修改记录

1. 闪光灯驱动IC由原来的OCP-OC98131AVAD 换成又为的AM6341EDMR
2. 大脚电感L210、电容C240
3. 将电容C201由原来的0201-2.2UF换成0402-10uF
4. 增加电容C202-0201-1uF, 增加电阻R211、R201[100K-0201], 增加电阻R208 (6603-0.5R-1%)
5. 将电阻R202由原来的90.9K换成49.9K, 将电阻R203由原来的13K换成0.5R
6. 删除电阻R611、R612 - - - - -20220324

- P1 修改内容 20220509
1. 21页, 删除电平转换芯片LQ110及其周边电路, 删除R2195~R2199、C2189、C2187。
 2. 21页删除器件IC4及其电路, 去掉电阻R2193、R2194

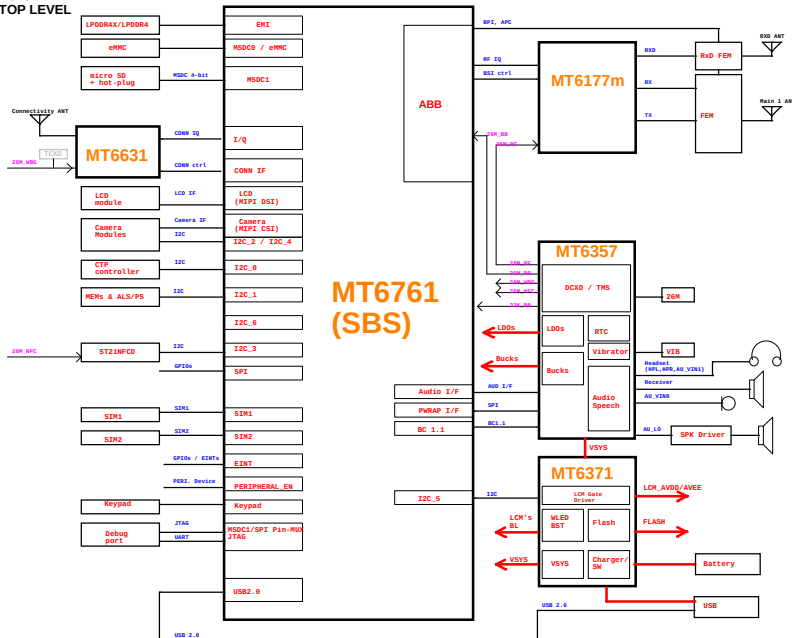
- 1、由于ID调整，OVP后端两个0欧姆电阻删除R1611、R1612(0603封装)

- 1、21页，QVGA IIC预留level shift，IIC通路增加R2194/R2193 OR电阻

2. 删除C21

2. 增加列试点

4. 更换60-PIN连接器J2601, 换成M355上的

1. 8279. 8411

2. 耳机参考地串接1.0K电阻R720
